Re: Zoning Commission Case No. 06-13
1000 Connecticut Avenue, N.W. PUD

Re: ZC Case No. 06-13
PUD – 1000 Connecticut Ave., N.W.

CONSOLIDATED PLANNED UNIT DEVELOPMENT AND MAP AMENDMENT FOR A MIXED-USE DEVELOPMENT AT 1000 CONNECTICUT AVENUE, NW

Executive Director's Recommendation

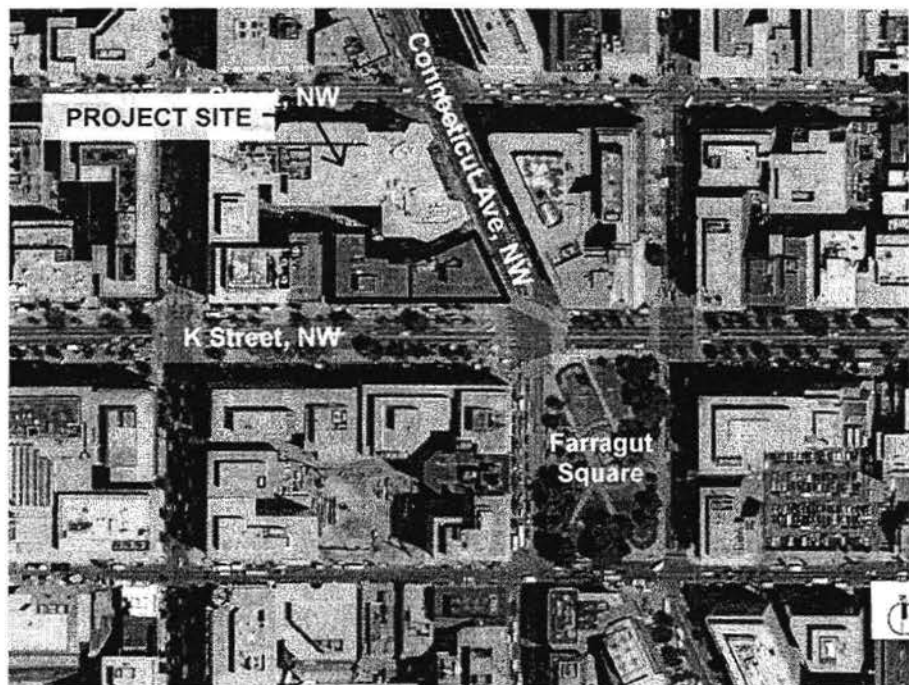
Advises that the parapet at the edge of the roof exceeds the allowable height as mandated by Section 7 of the Height of Buildings Act, which states that "no parapet walls shall extend above the limit of height."

Recommends that the Zoning Commission require the applicant to modify the design to eliminate the parapet, or set it back from the exterior walls to distances equal to their respective heights above the adjacent roof.

PROJECT ANALYSIS

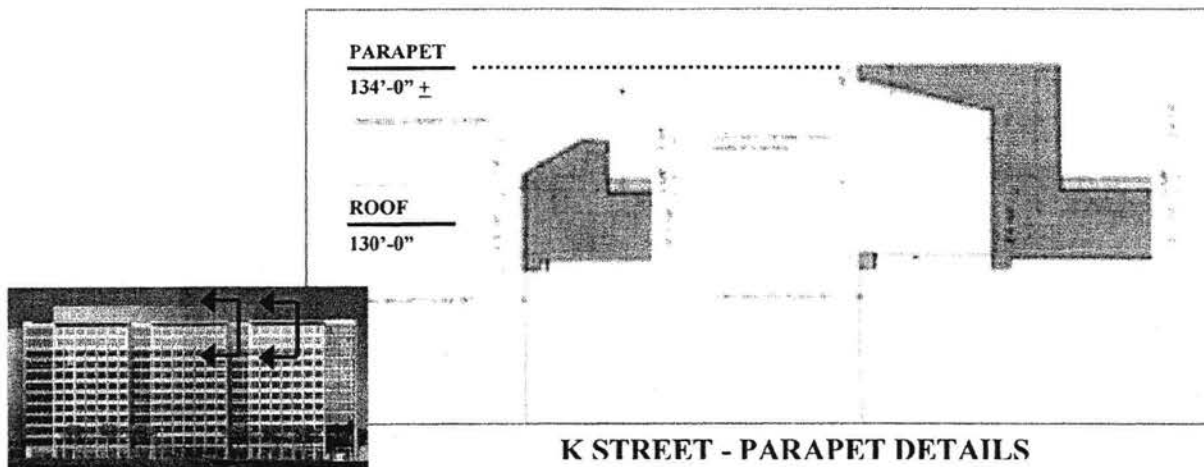
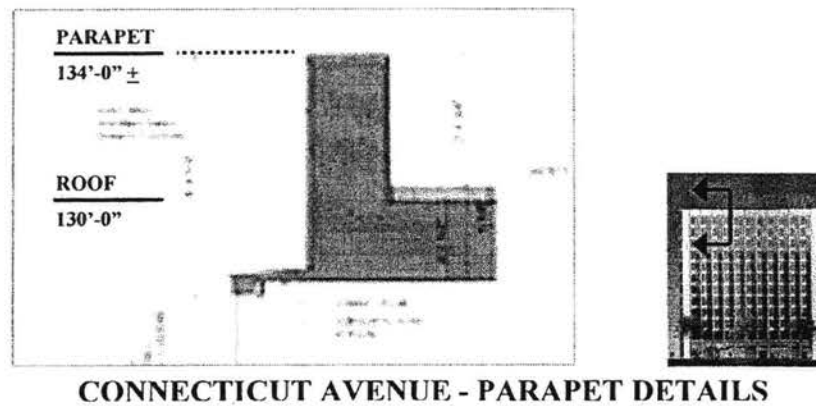
Staff finds that the parapet heights along the K Street and Connecticut Avenue façades are in conflict with the federal Height of Buildings Act of 1910. Section 5 of the Height Act states that “No building shall be erected, altered, or raised in any manner as to exceed the height of one hundred and thirty feet...” and Section 7 of the Act states that, “no parapet walls shall extend above the limit of height.”

Based on the architectural drawings included in the submission, the top elevation of the parapet is approximately four feet (4') above the allowable height of 130 feet; if the parapet were set back from the edge or the roof at a 1:1 height/setback ratio, however, it could be constructed within the requirements of the Act.

A penthouse at the middle of the roof also exceeds the façade plane height restriction; however, since the penthouse is set back from the roof within the required 1:1 ratio established by the Height of Buildings Act, staff finds the penthouse to conform to the Act's requirements.

Staff therefore recommends that the Zoning Commission require the applicant to modify the design to eliminate the parapet, or set it back from the exterior walls to distances equal to their respective heights above the adjacent roof.

PARTIAL ELEVATION - K STREET

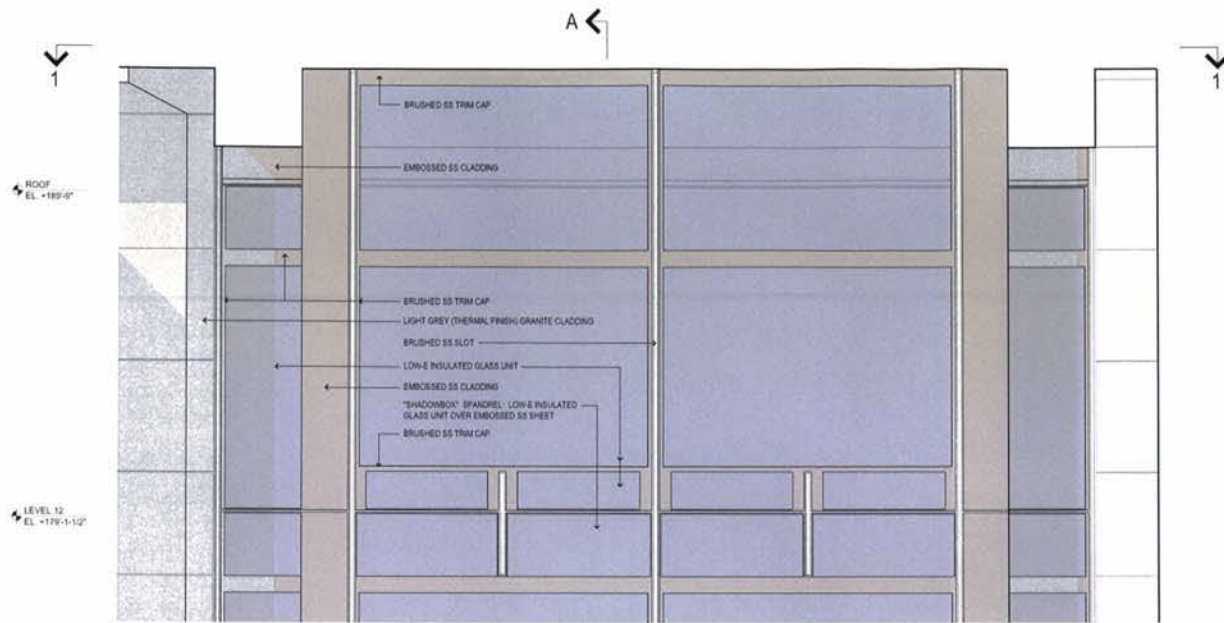
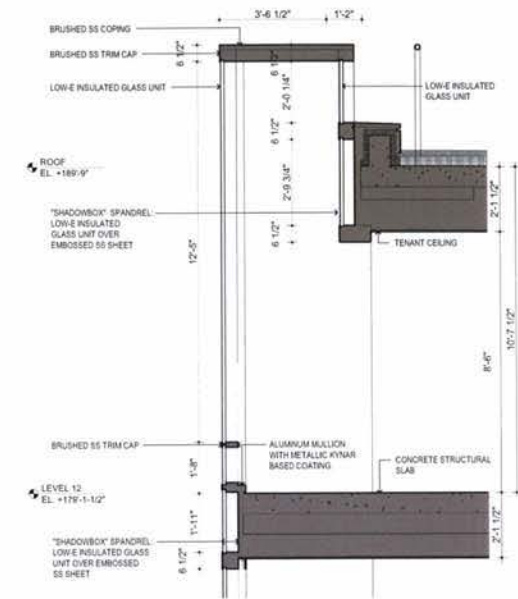
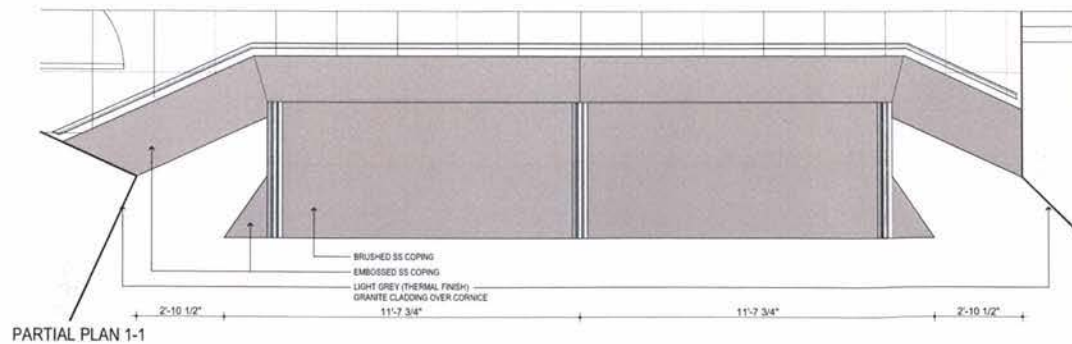
1. **K Street:** Along the top of the "stone" pavilions at K Street, a stone clad "cornice" provides important distinction and depth to each pavilion (ref. A-32, left hand image). The vertical dimension of the cornice extends 4 feet above roof level, while the horizontal section extends out to, but not over, the K Street property line.
